# Lot 8 TBD Graham Mills Lane

NSITE HOMES WAKEFIELD

ELEVATIONS

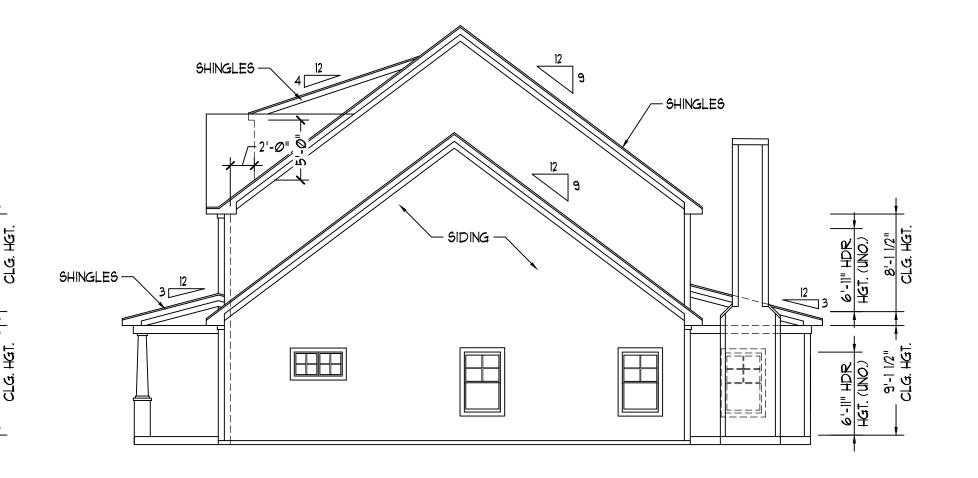
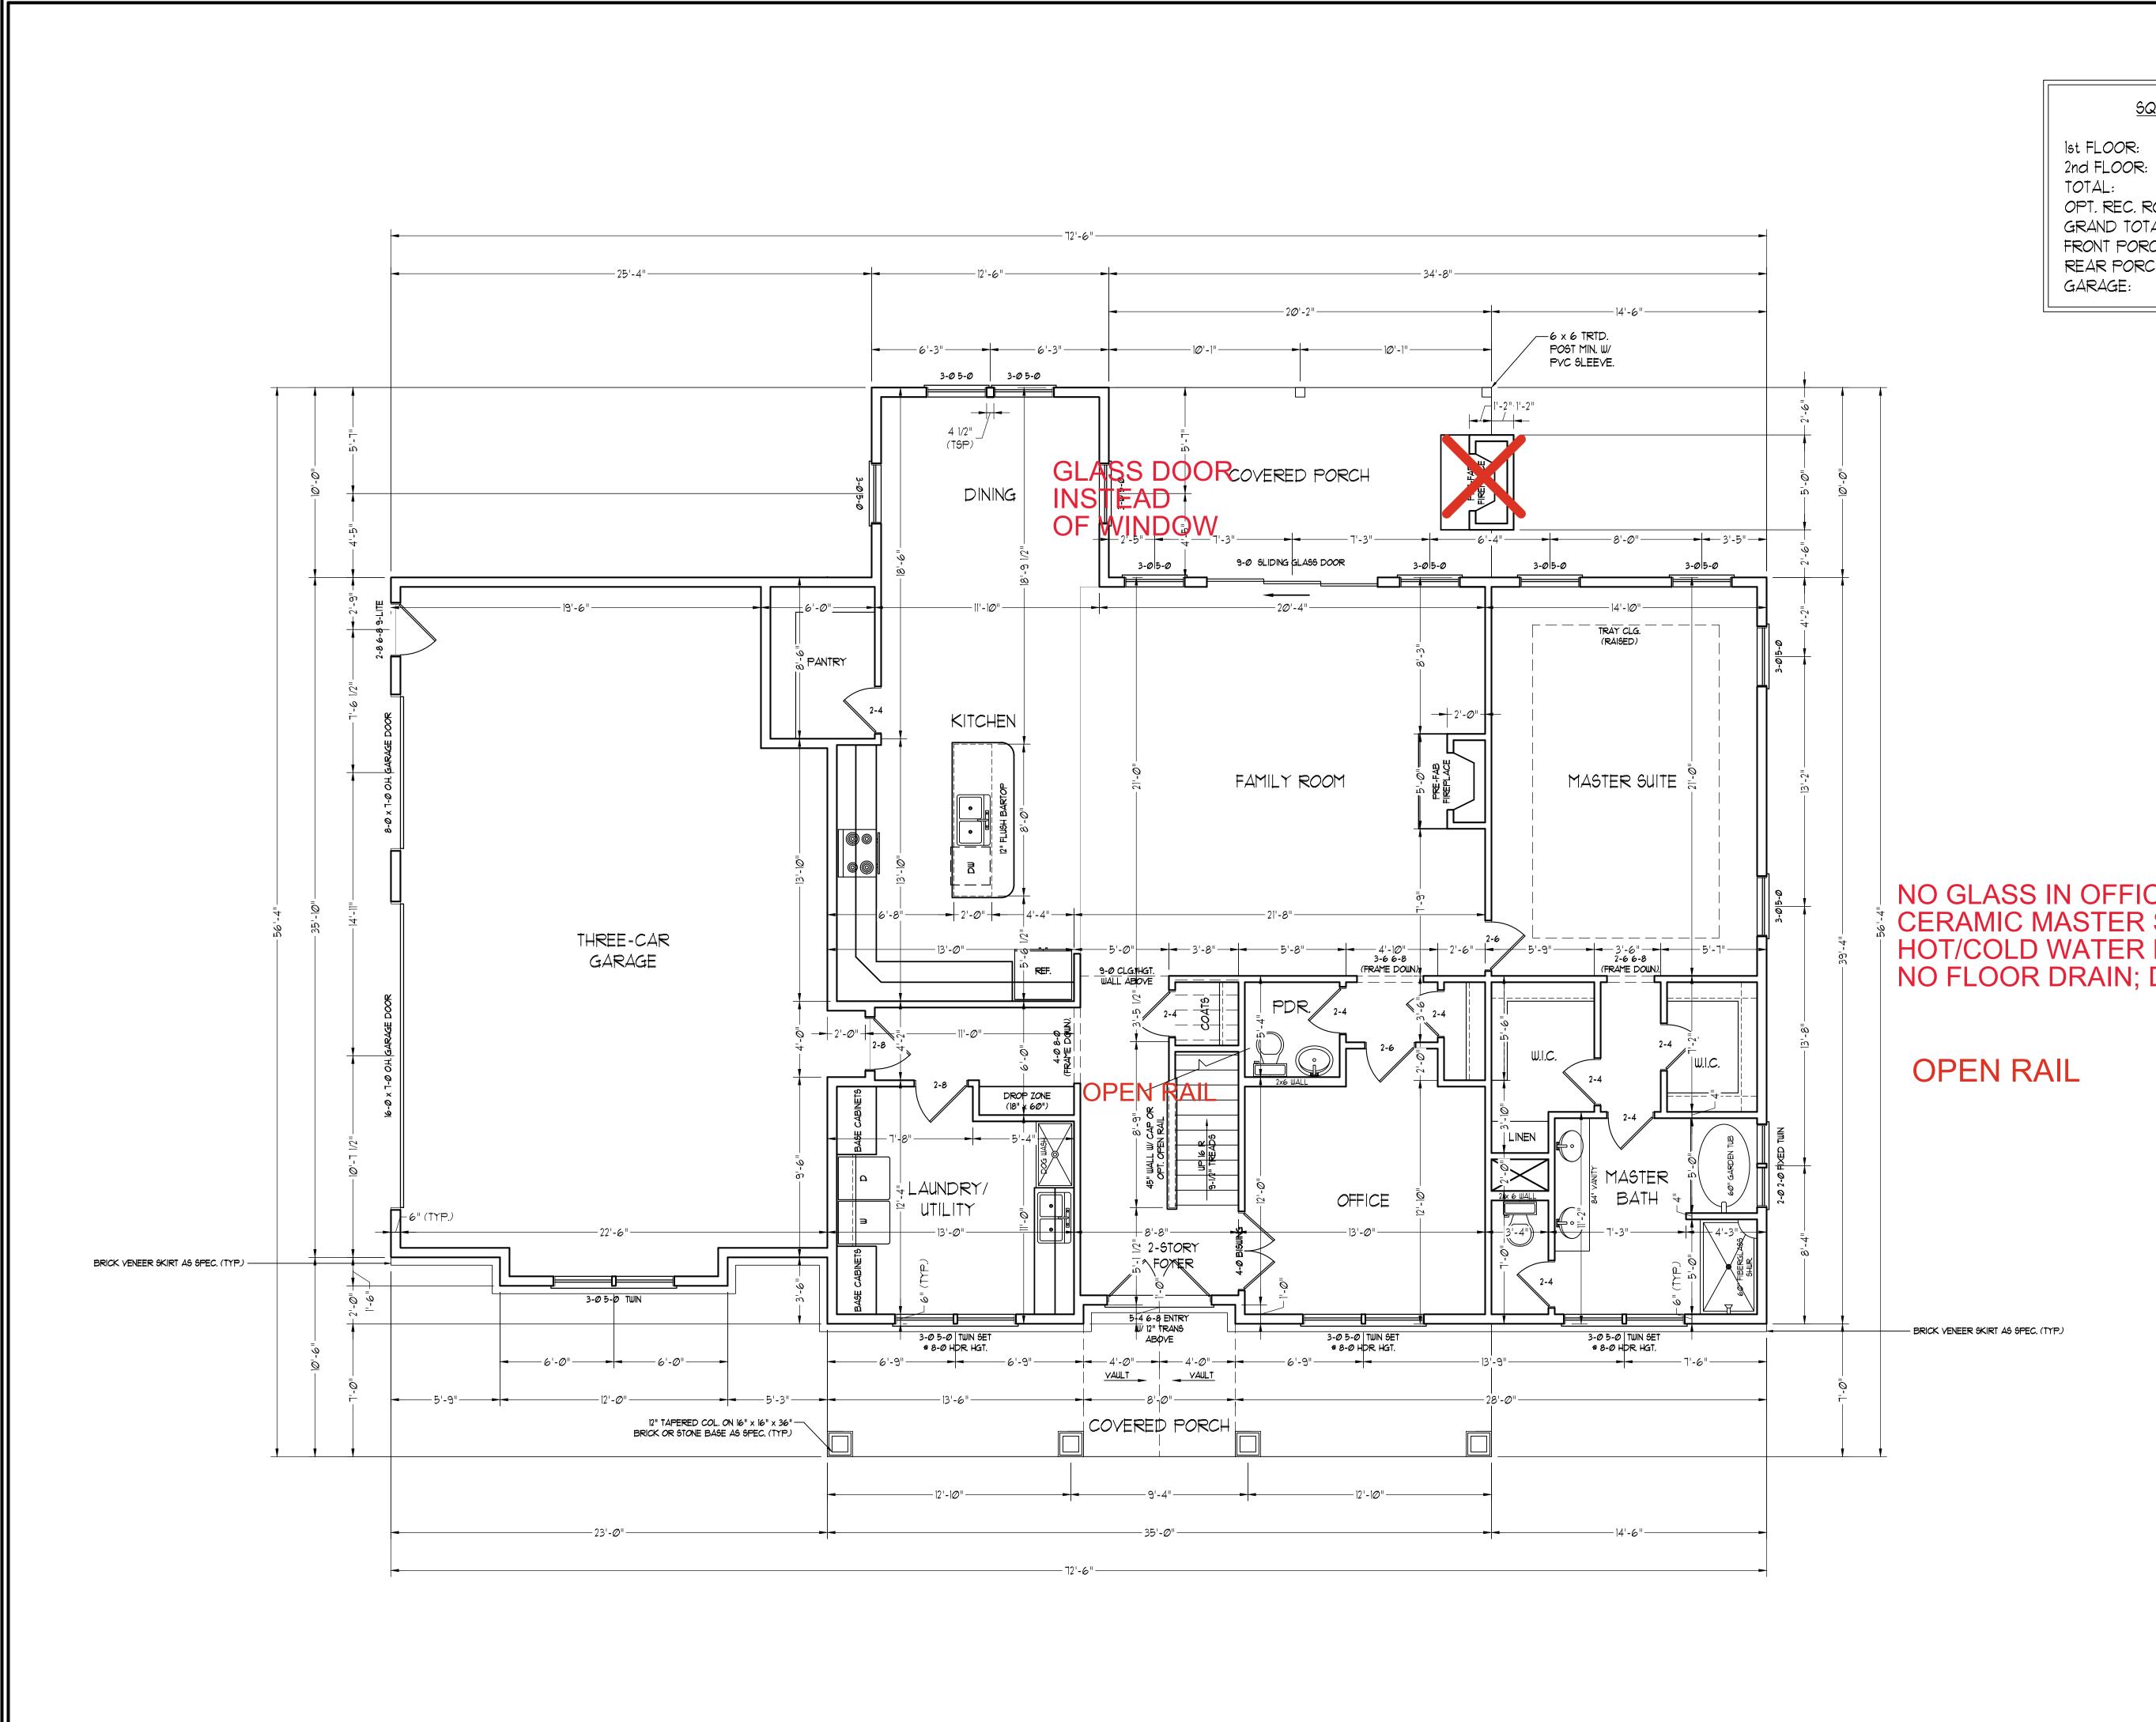
Case all openings gravel w/concrete parking & turn around pad 50 amp outlet in detached garage wire & separate panel Gourmet Kitchen Sod full yard STONE SKIRT STONE AT BASE OF COLUMNS BRICK STEM WALL

NO OPEN RAILS INSIDE HOUSE; NO PICKETS

WAYNE DALTON MODEL 9100-RANCH GARAGE DOOR WITH STOCKTON 2 INSERTS IN TOP PANEL.

NO GLASS IN BISWING OFFICE DOORS

CERAMIC MASTER SHOWER HOT AND COLD WATER LINES FOR DOGWASH; DRAIN TO GO INTO WALL, NOT INTO FLOOR OAK TREADS
